Date	Rev.	Status or Amendment
28/08/17	A	Issue for DA Amendment

Pursuant to section 197 of the *Planning and Development Act 2007*, approval is sought to amend development approval No. 201630289 dated 13/12/2016 as described at **Attachment A.**

Project: Canberra Labor Club Belconnen Hotel
Blocks: 8+9 | Section: 48 | Division: Belconnen
Drawing Title: Ground Floor Plan
Job No.: 16_35 | Drawing No.: DA-A101 | Scale: 1 : 100@A1 | Rev.: F

Drawing Title
East Elevation

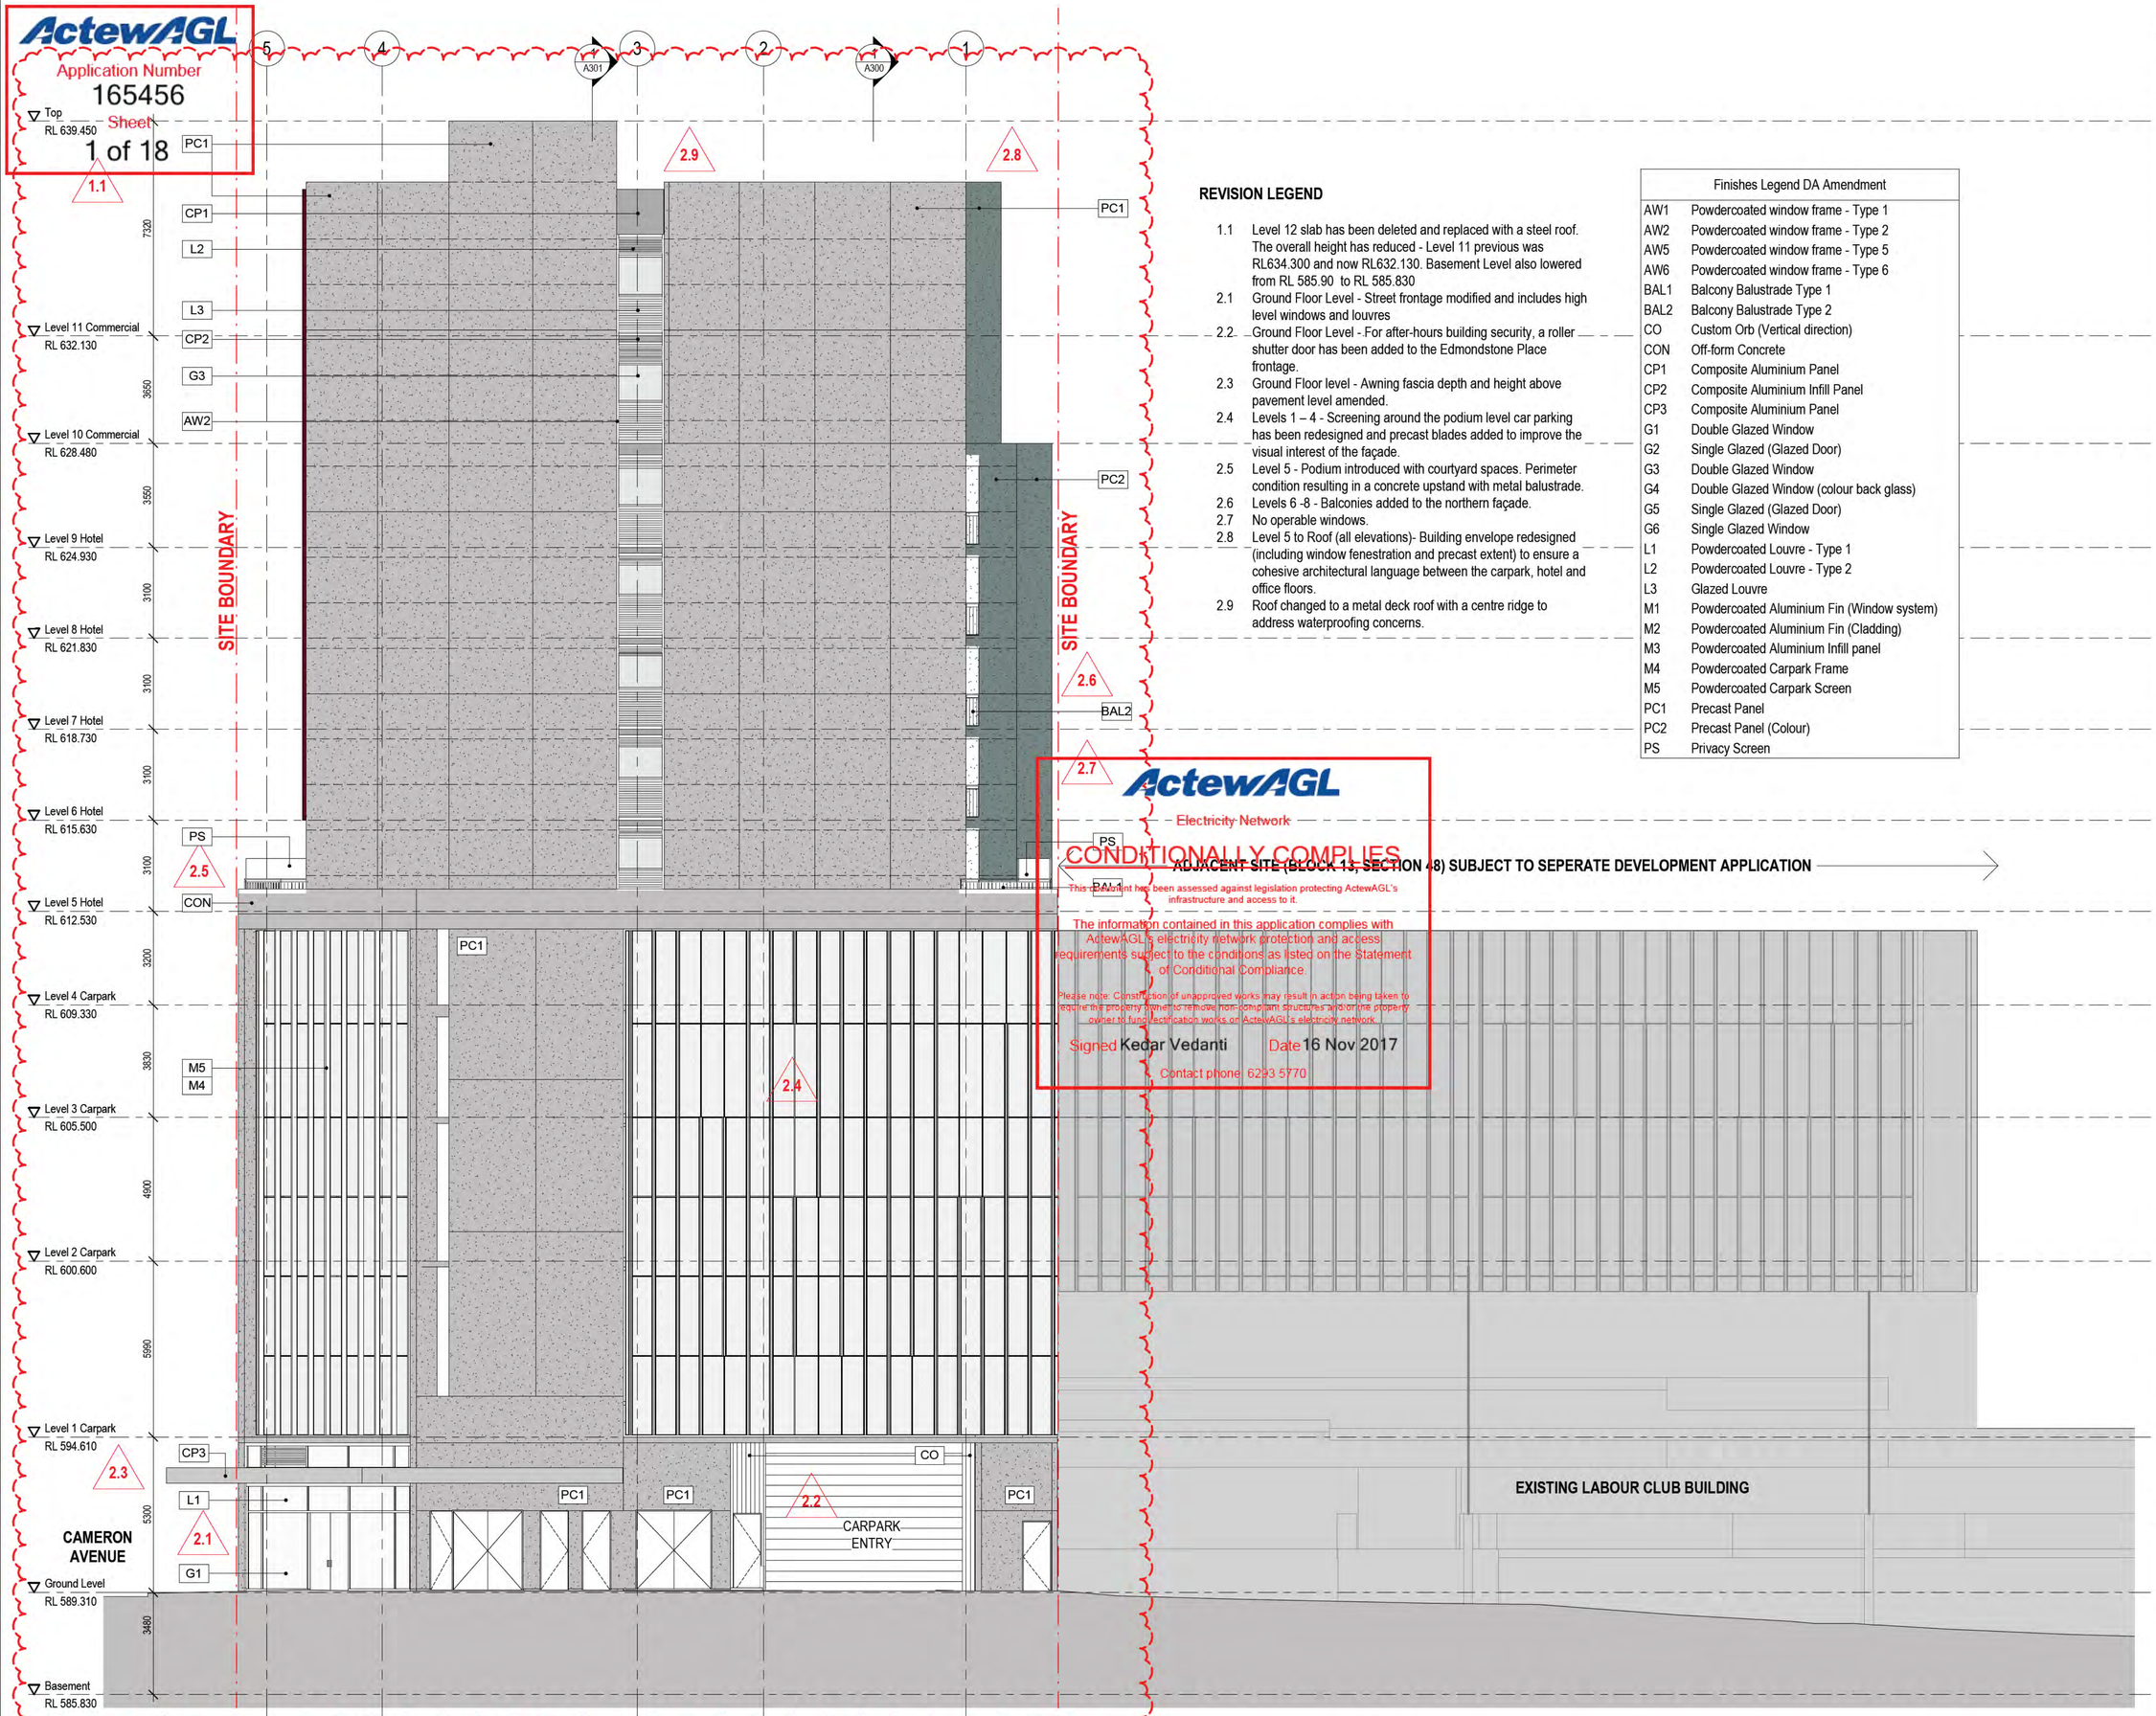
1.1 Level 12 slab has been deleted and replaced with a steel roof. The overall height has reduced - Level 11 previous was RL634.300 and now RL632.130. Basement Level also lowered from RL 585.90 to RL 585.830

2.1 Ground Floor Level - Street frontage modified and includes high level windows and louvres

2.2 Ground Floor Level - For after-hours building security, a roller shutter door has been added to the Edmondstone Place frontage.

2.3 Ground Floor level - Awning fascia depth and height above pavement level amended.

2.4 Levels 1 – 4 - Screening around the podium level car parking has been redesigned and precast blades added to improve the visual interest of the façade.

2.5 Level 5 - Podium introduced with courtyard spaces. Perimeter condition resulting in a concrete upstand with metal balustrade.

2.6 Levels 6 -8 - Balconies added to the northern façade.

2.7 No operable windows.

2.8 Level 5 to Roof (all elevations)- Building envelope redesigned (including window fenestration and precast extent) to ensure a cohesive architectural language between the carpark, hotel and office floors.

2.9 Roof changed to a metal deck roof with a centre ridge to address waterproofing concerns.

Drawing Title
South Elevation

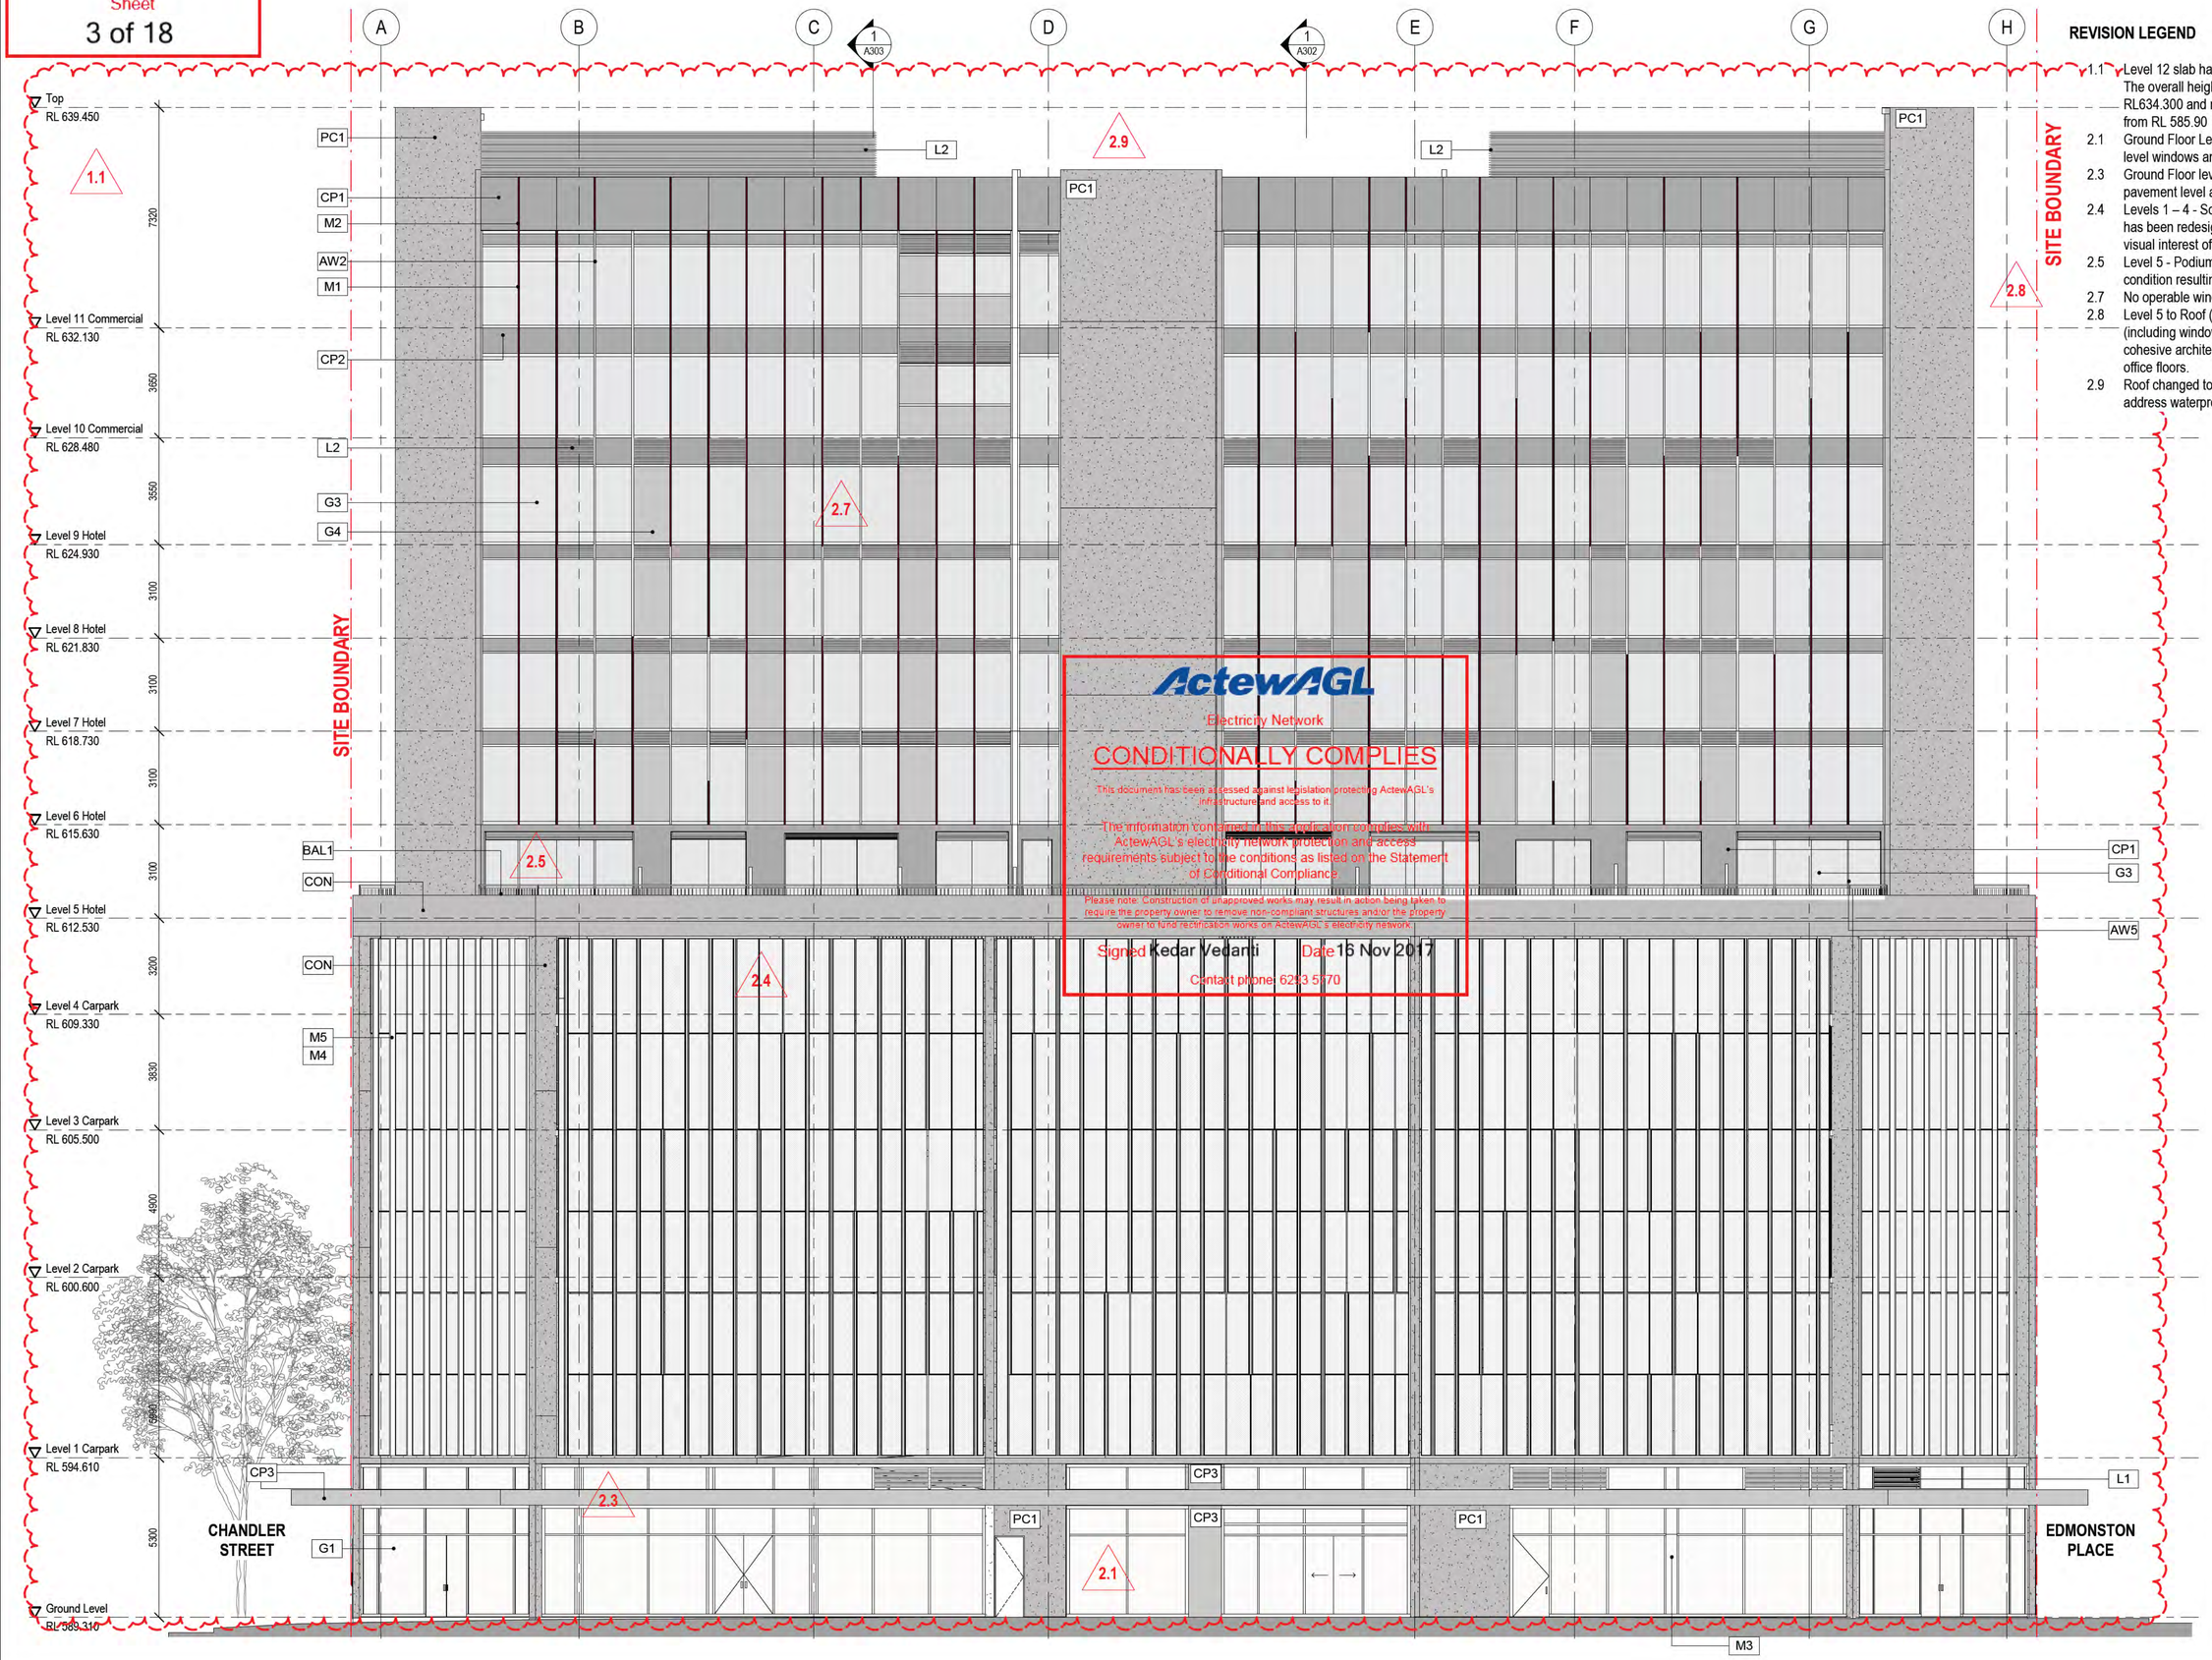
2.1 Ground Floor Level - Street frontage modified and includes high level windows and louvres
2.3 Ground Floor level - Awning fascia depth and height above pavement level amended.

2.4 Levels 1 – 4 - Screening around the podium level car parking has been redesigned and precast blades added to improve the visual interest of the façade.
